# Town of Washington Zoning Commission

## Special Permit Application

Proposed Use: DETACHED ACCESSORY APARTMENT

RE: Review of Engineering Plan for Subsurface Sewage Disposal System located at:  
143 Lower Church Hill Road - Washington Garage/Guest House

**PROPOSED SITE PLAN #143**  
**LOWER CHURCH HILL ROAD**  
**WASHINGTON, CONNECTICUT**

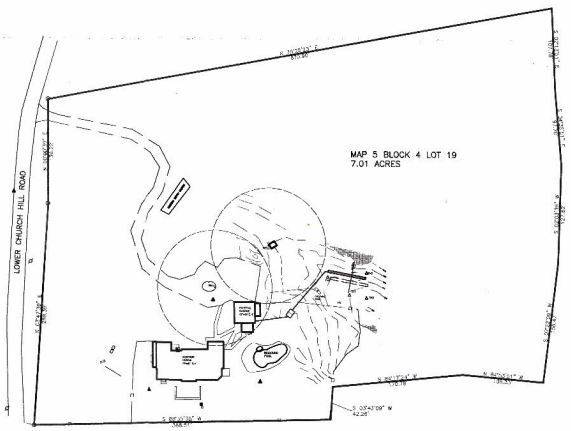
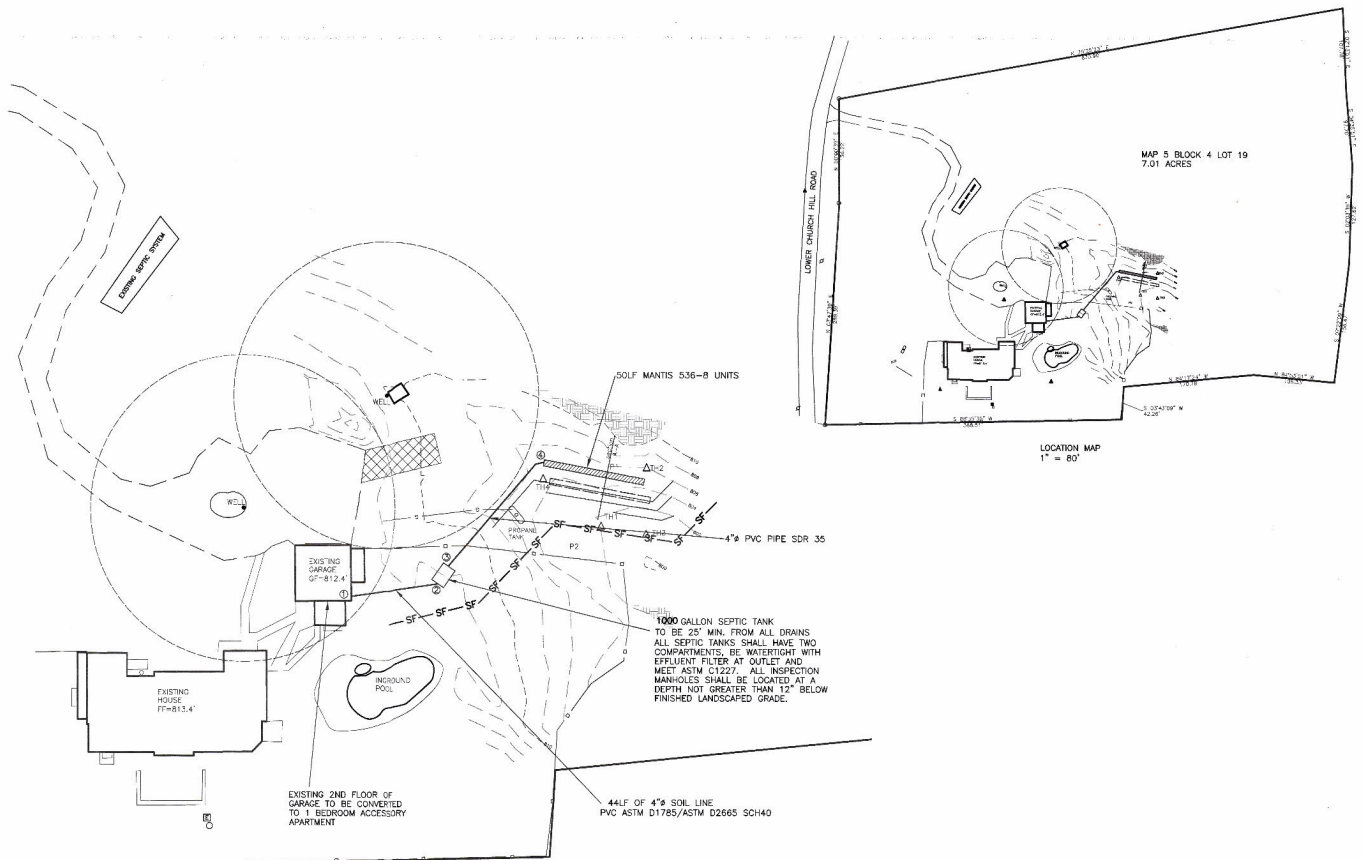
**This system does not provide for water softener discharges OR kitchen garbage grinders.**  
**1. Engineer to stake all components of the septic system prior to construction. 2. Engineer to approve quantity, quality and placement of select fill (C33). 3. A sieve analysis is to be submitted to the Health Department. 4. Engineer to submit an as-built to the Health Department.**
